**ADDENDUM NO. 5
IRONDALE PUBLIC LIBRARY**

CITY OF IRONDALE

THIS ADDENDUM FORMS A PART OF THE CONTRACT DOCUMENTS. THE FOLLOWING CONDITIONS TAKE PRECEDENCE OVER ANY CONFLICTING CONDITIONS IN THE DRAWINGS AND SPECIFICATIONS. THE DRAWINGS AND SPECIFICATIONS ARE HEREBY AMENDED IN THE FOLLOWING PARTICULARS.

C5.02

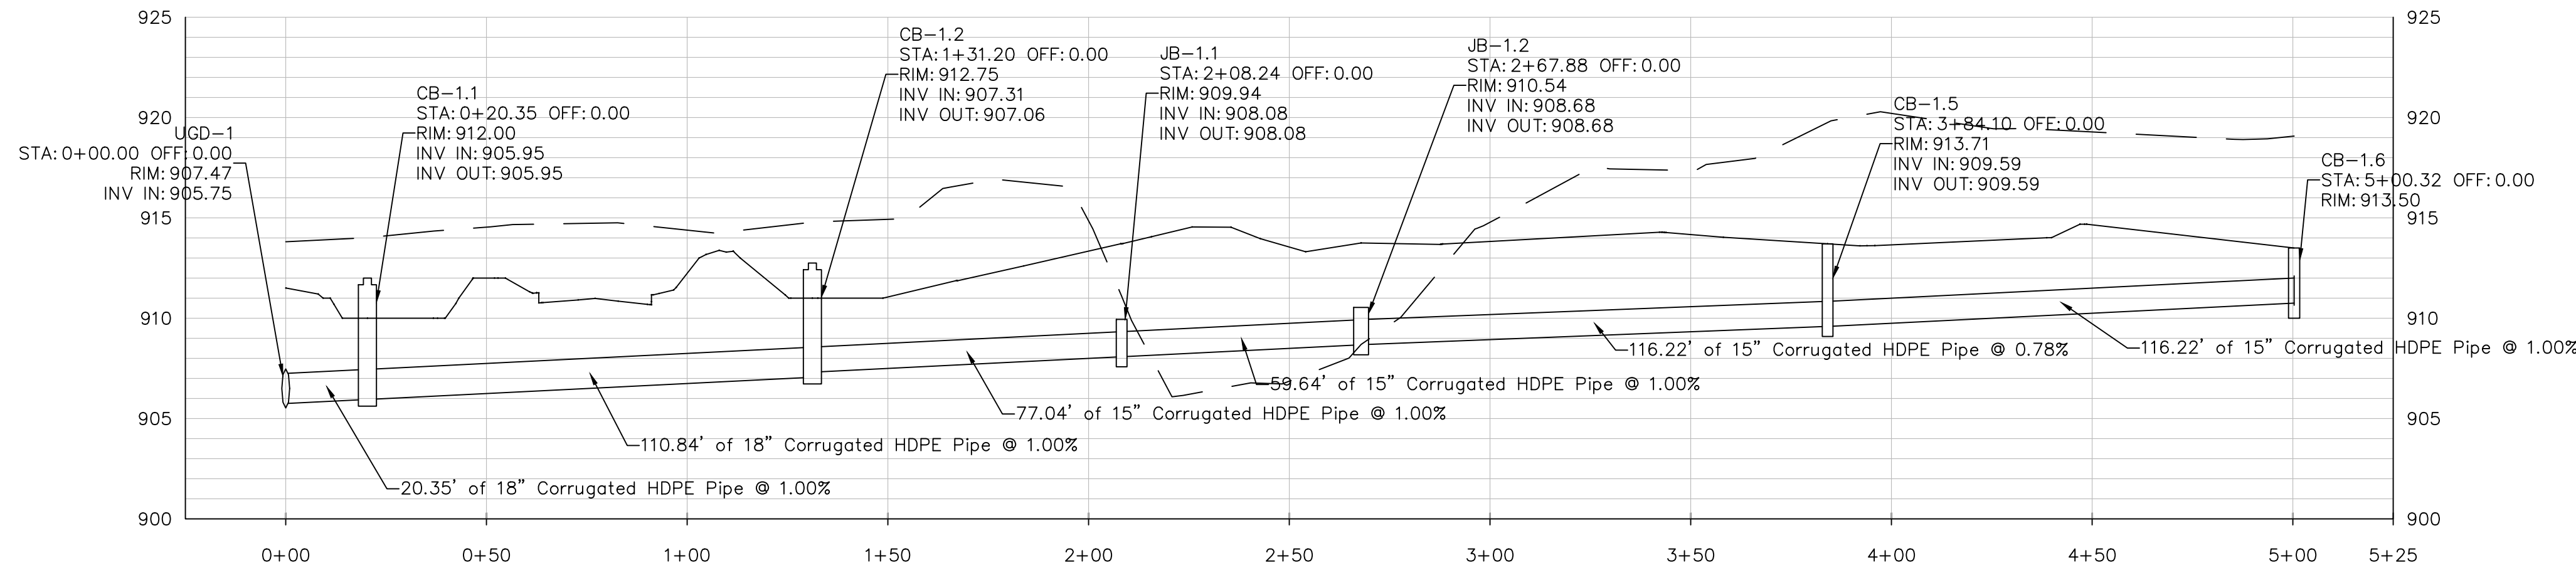
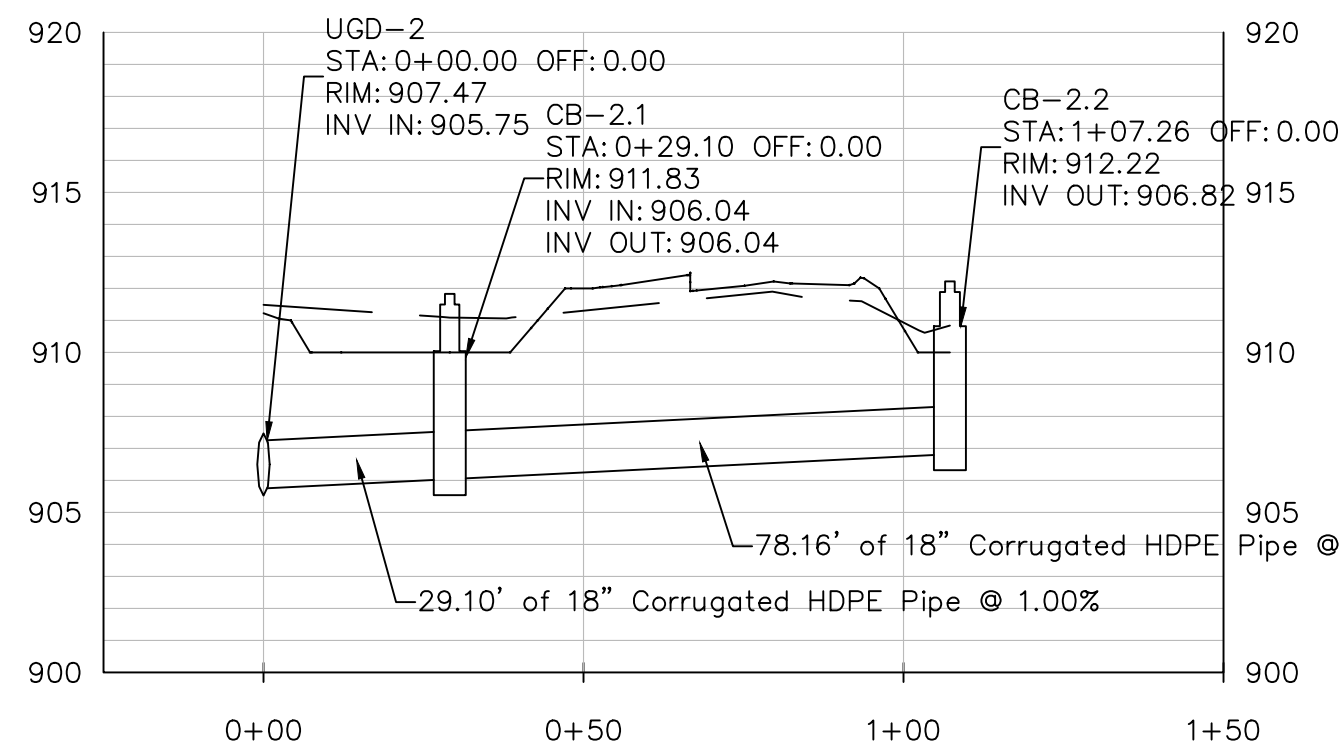
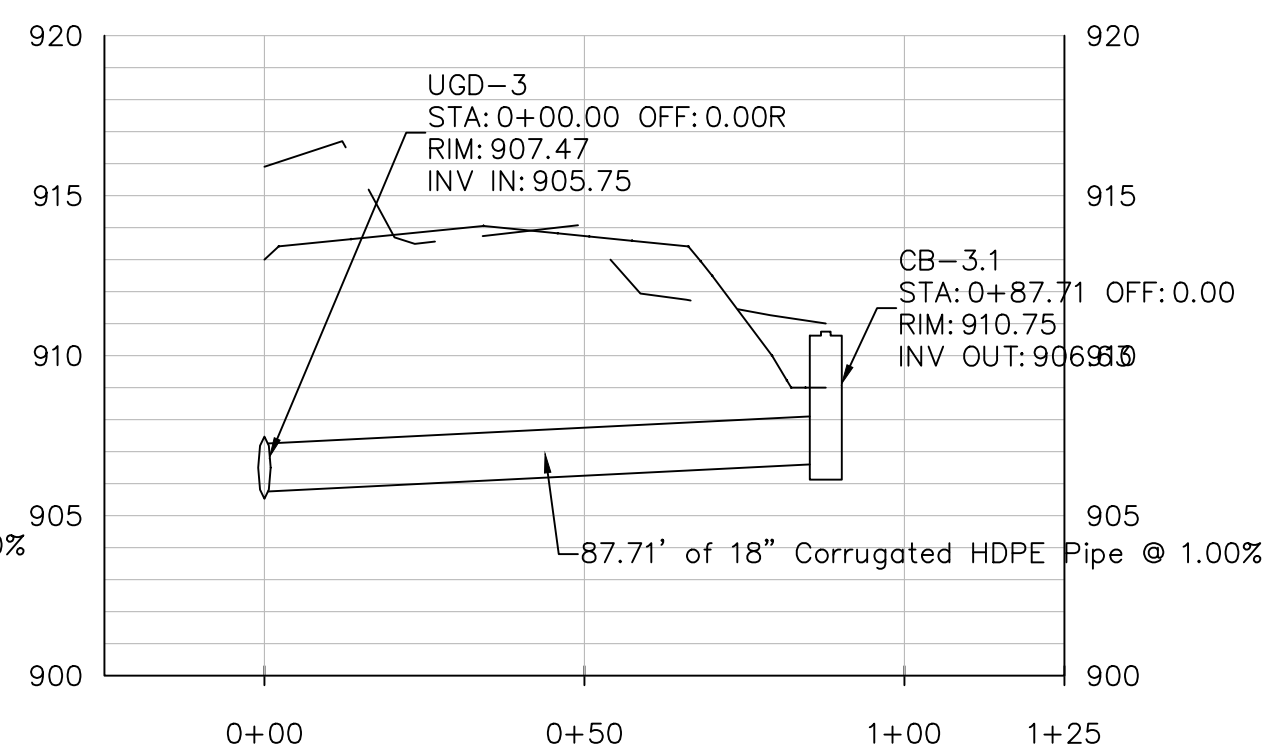
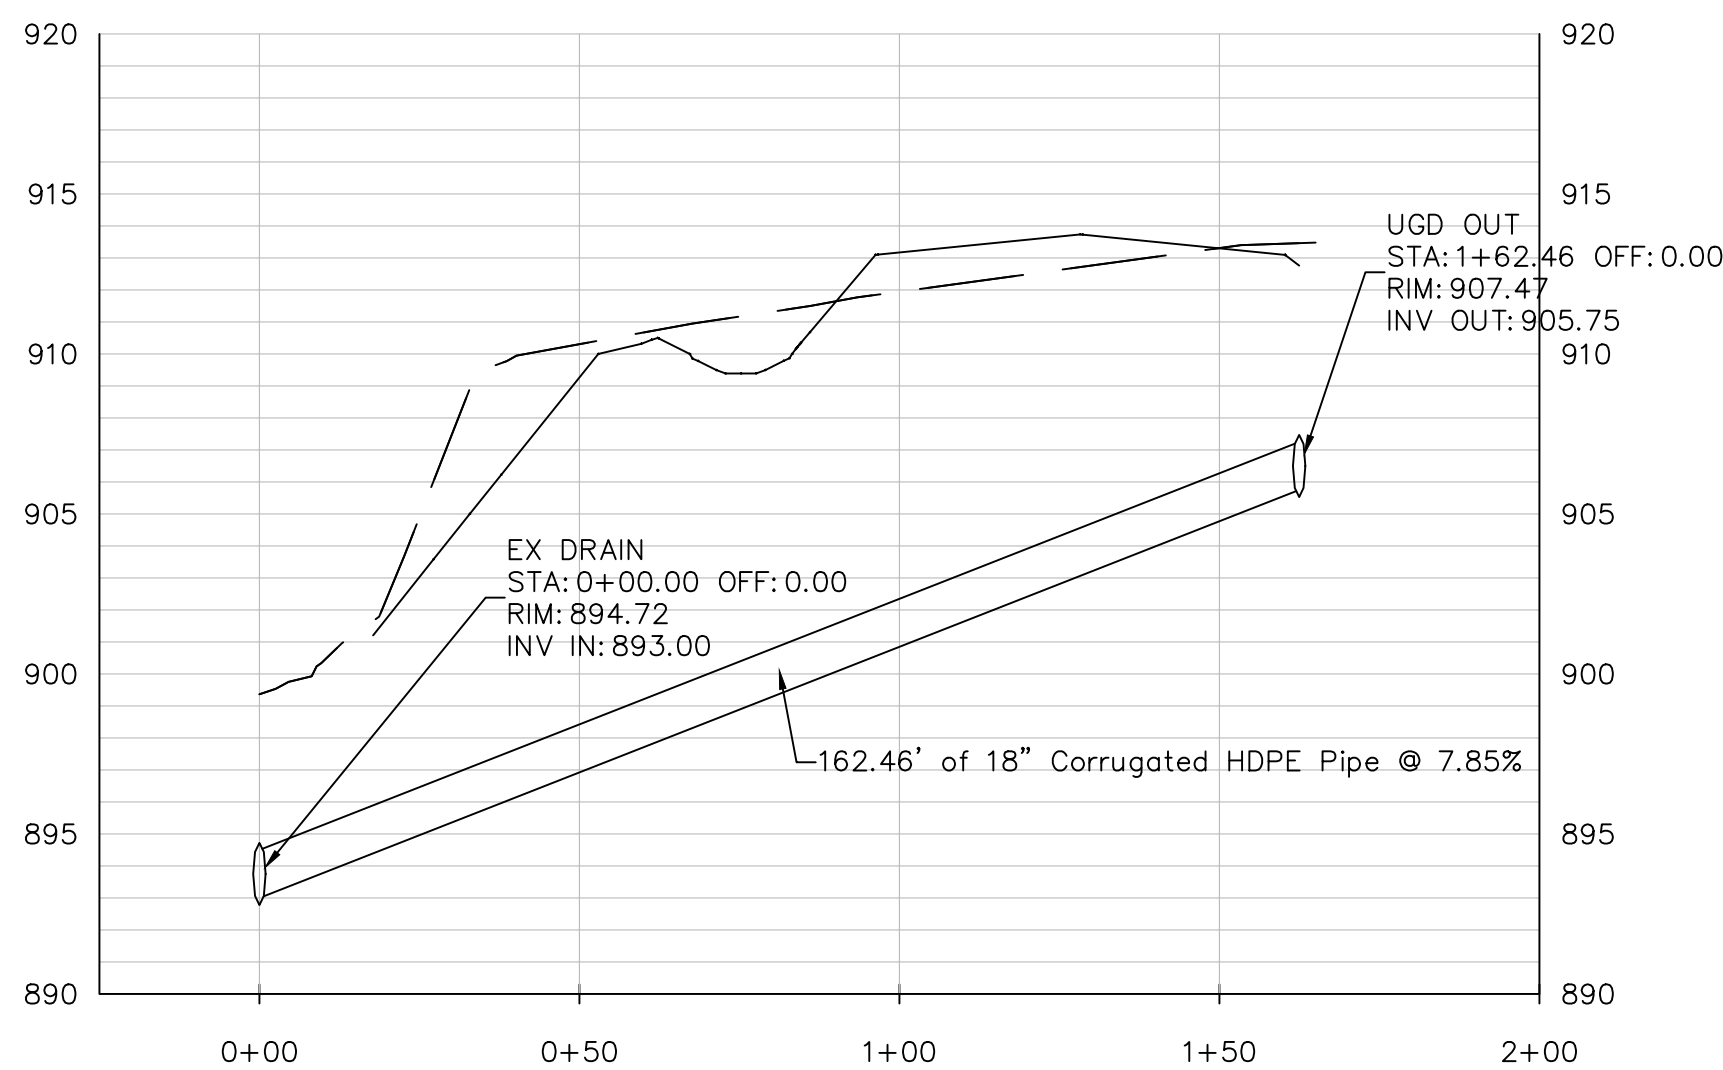
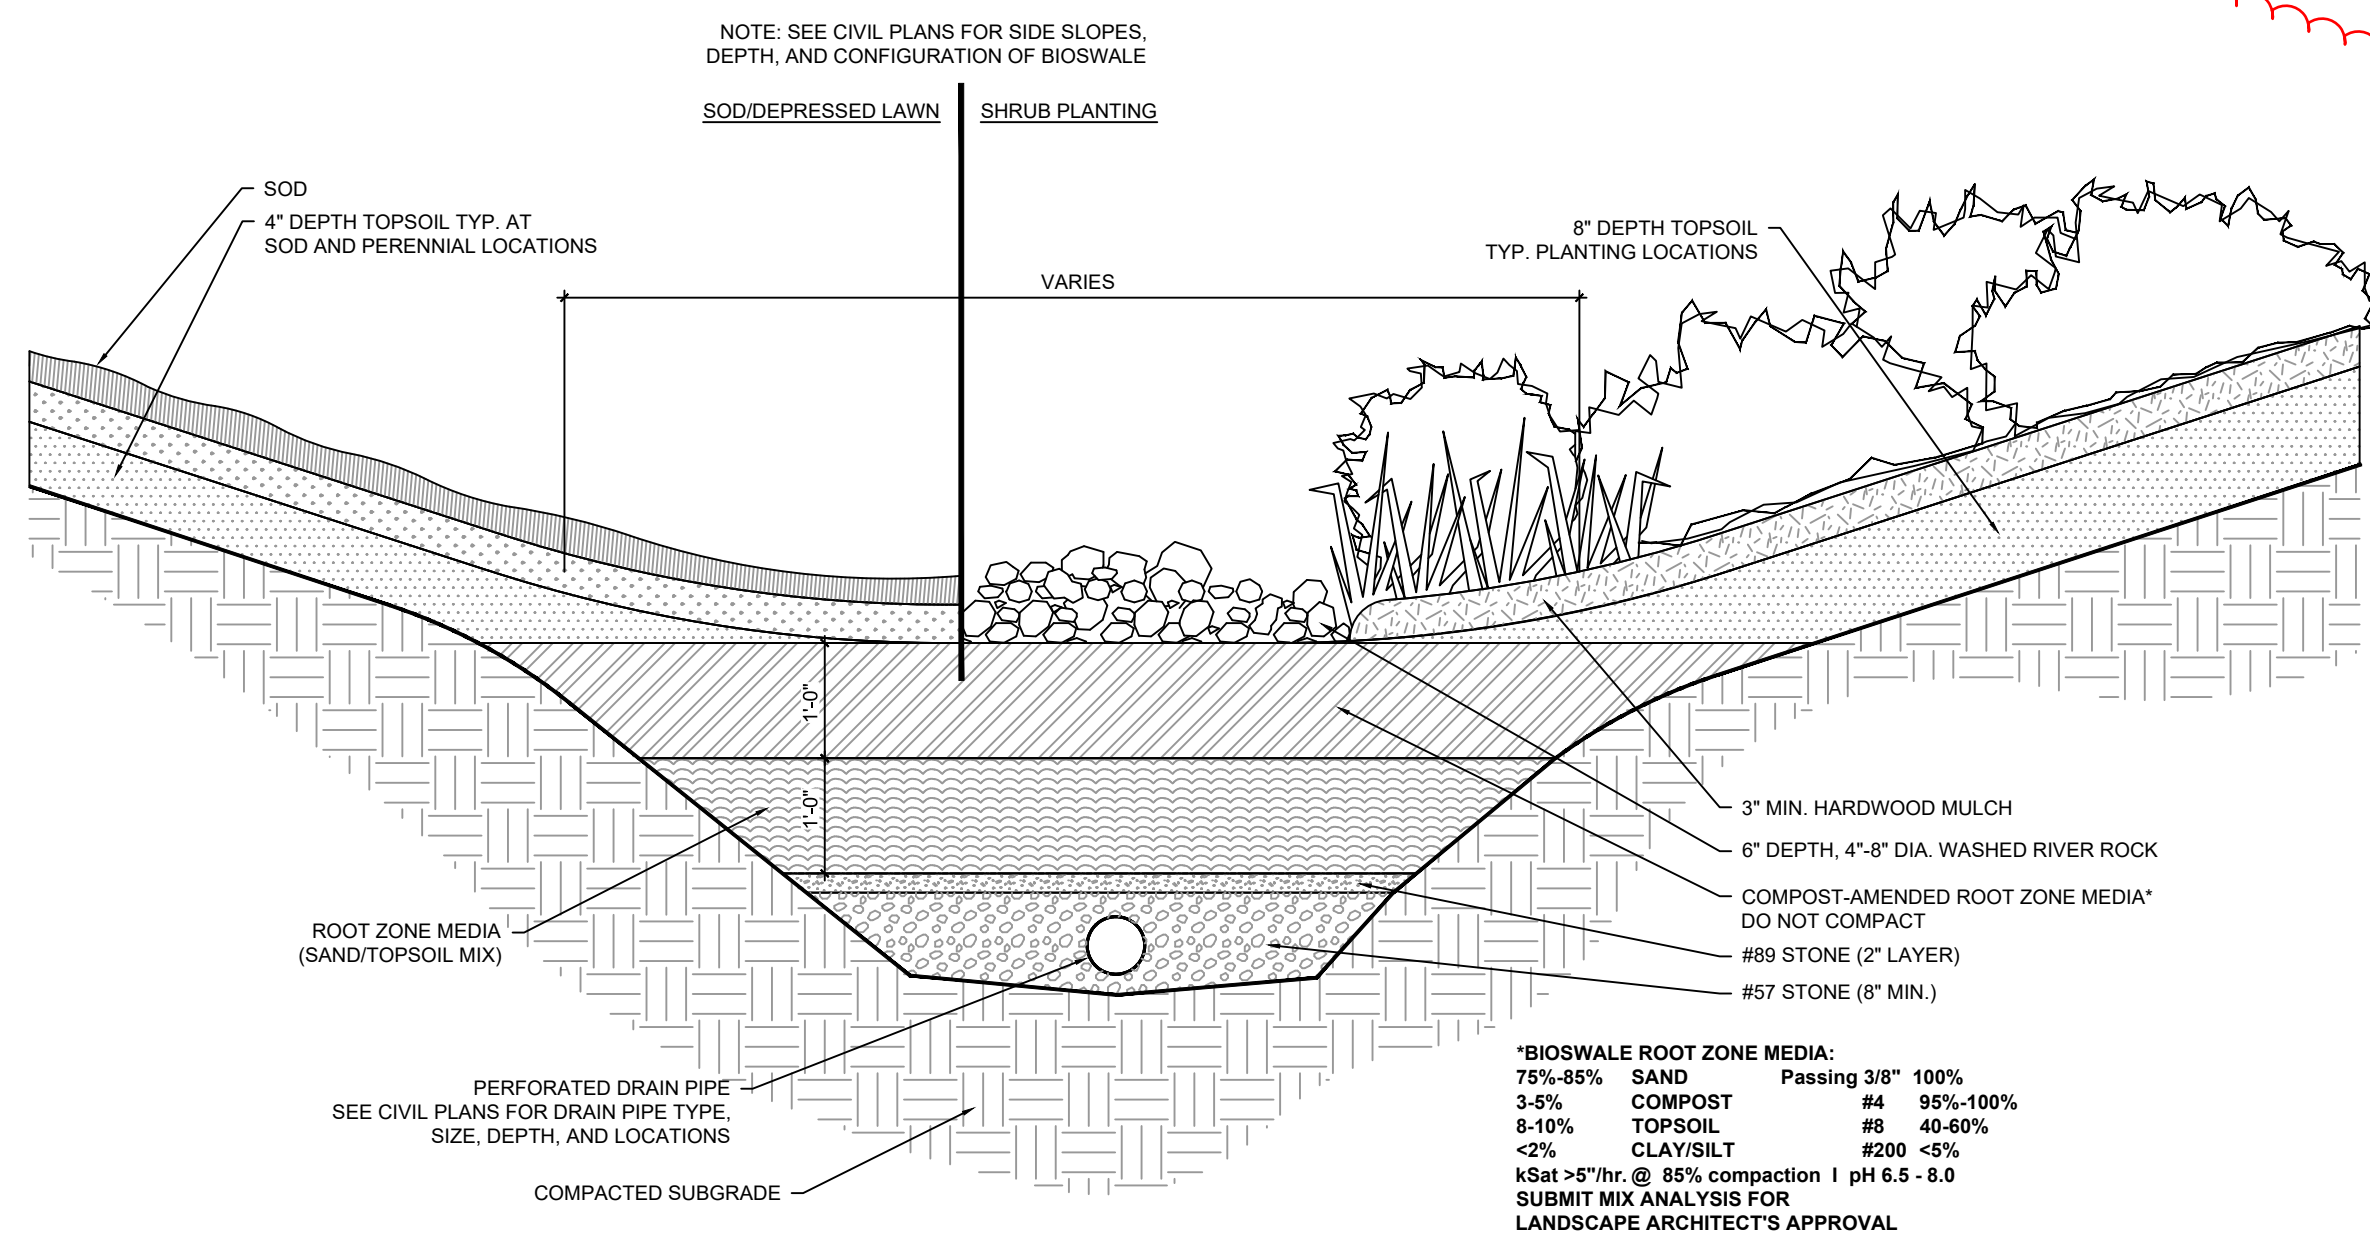
5. Sheet C5.01
 - a. Reprint sheet issued in Addendum 4 due to corrupted file.
6. Sheet C5.02
 - a. Added drain line behind building to profile view
 - b. Added bioretention cell detail
